TEDDER RIVER  
BRIDGE

T7725  
REPORT  
TO  
DEPARTMENT OF HIGHWAYS, ONTARIO  
MATERIALS AND RESEARCH DIVISION  
ON  
SOIL CONDITIONS AND FOUNDATIONS  
PROPOSED TEDDER RIVER BRIDGE  
TOWNSHIP 66  
DISTRICT OF ALGOMA                      ONTARIO

FOUNDATION INVESTIGATION REPORT BY:  
Geocon, Ltd., Consulting Engrs., Toronto.  
Proposed Tedder River Structure on Sec. Hwy. 631,  
Line 'A', Twp. 66, District 18, (Sault Ste. Marie).  
W.P. 151-64

BORE HOLE LOCATIONS &amp; SOIL STRAT

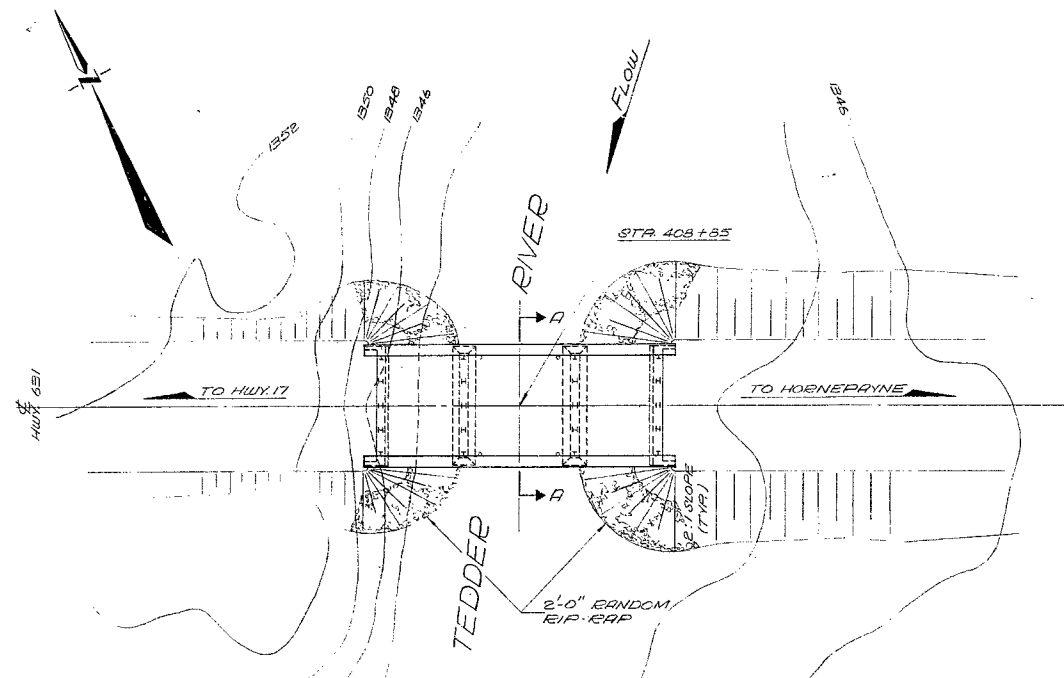
Four boreholes with accompanying dynamic penetration tests and two additional dynamic penetration tests were put down using a skid mounted diamond drill rig. The locations of the boreholes is given on Drawing T7725-1, at the rear of this report. A detailed log of each borehole is given on the Office Reports on Soil Exploration in this Appendix.

APPENDIX II  
FIGURE 2  
PROJECT T7725

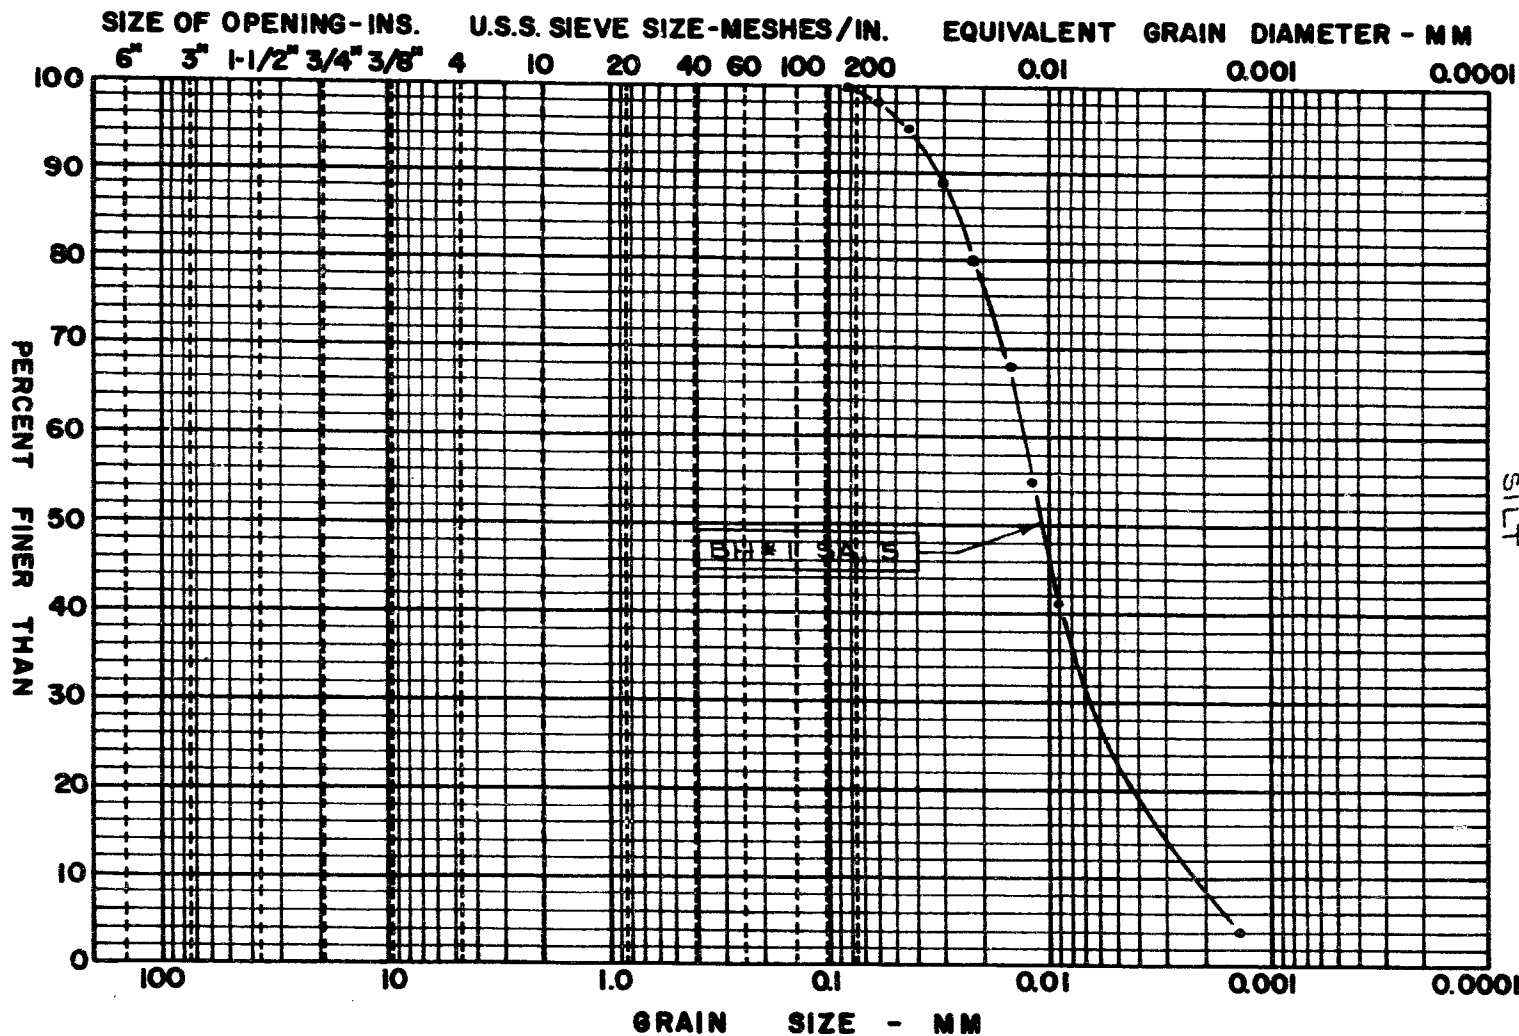
A mechanical analysis was carried out on a sample from this stratum and the results plotted on Figure 2 in Appendix II. The sample contained 93 percent silt sizes and 7 percent clay sizes.
